Form 3160-5
(June 2019)

SUNDRY NOTICES AND REPORTS ON WELLS
Do not use this form for proposals to drill or to re-enter an abandoned well. Use Form 3160-3 (APD) for such proposals.

Antietam 9 Fed Com 108H API #: 30-025-52244

EOG respectfully requests an amendment to our approved APD for this well to reflect the following changes:

Proposed Wellbore

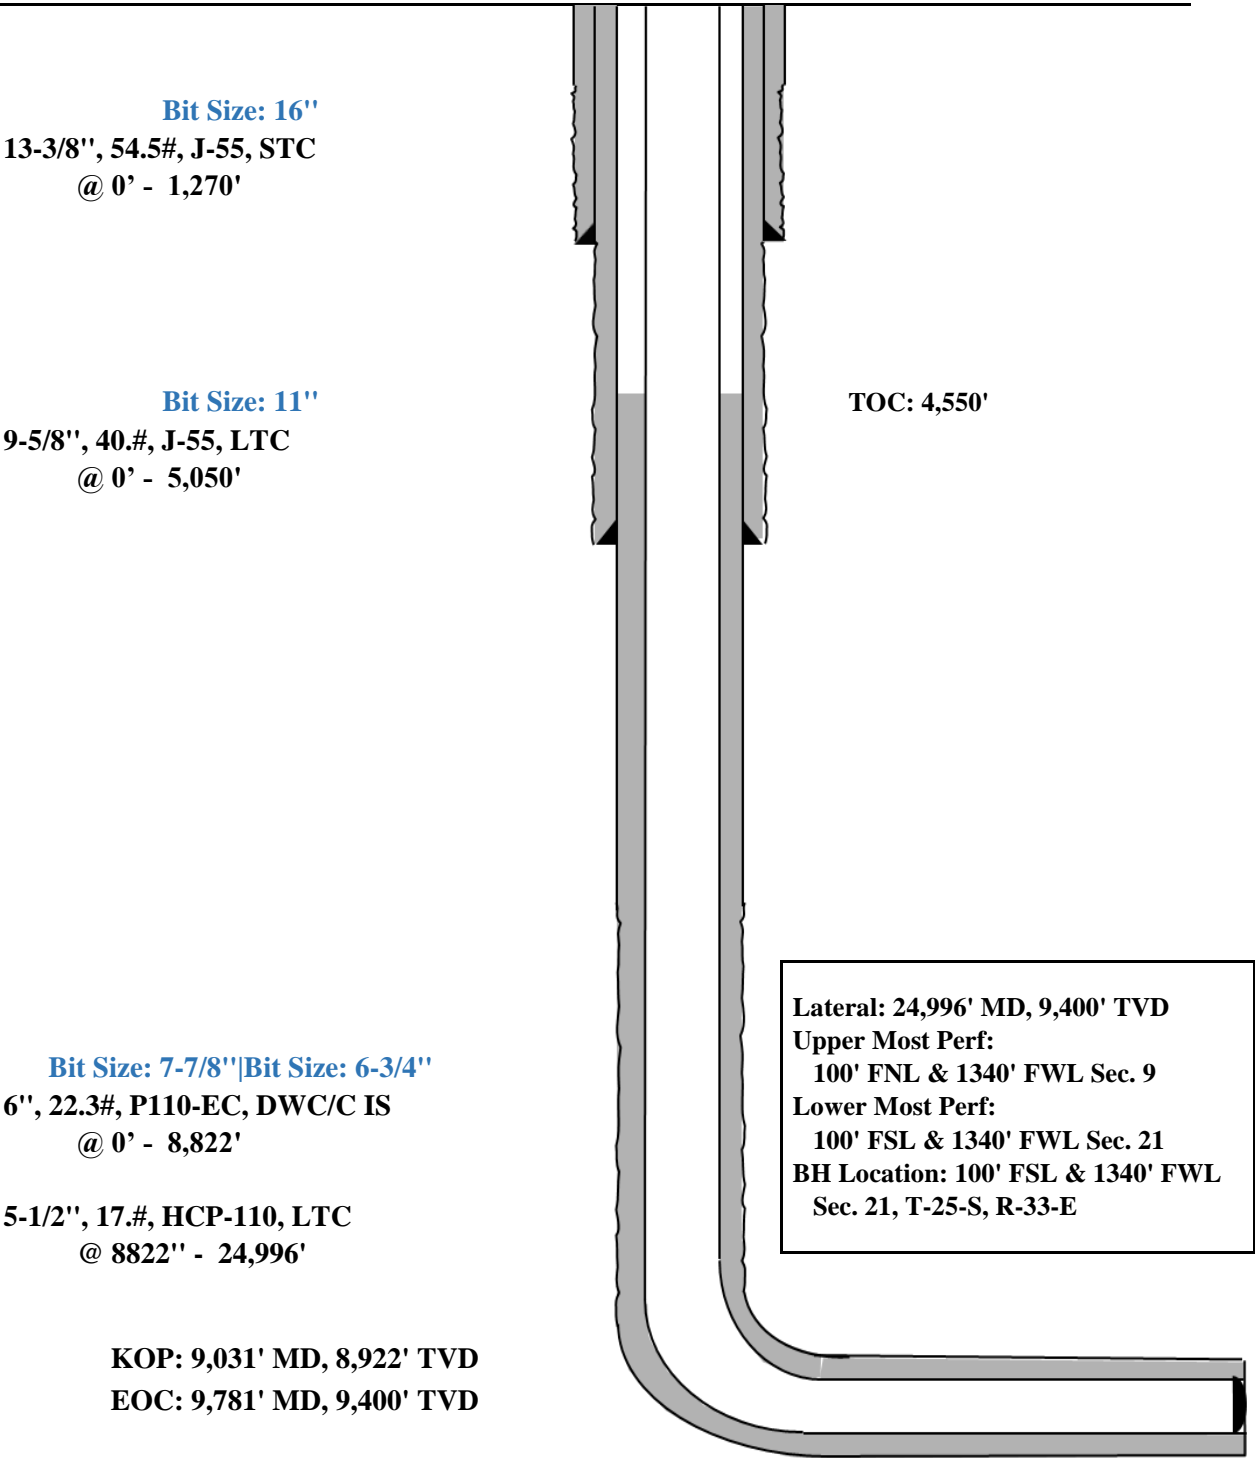
Change BHL from T-25-S, R-33-E, Sec 16, 2540' FNL, 2110' FWL, Lea Co., NM,
to T-25-S, R-33-E, Sec 21, 100' FSL, 1340' FWL, Lea Co., N.M.

Update casing and cement program to current design.
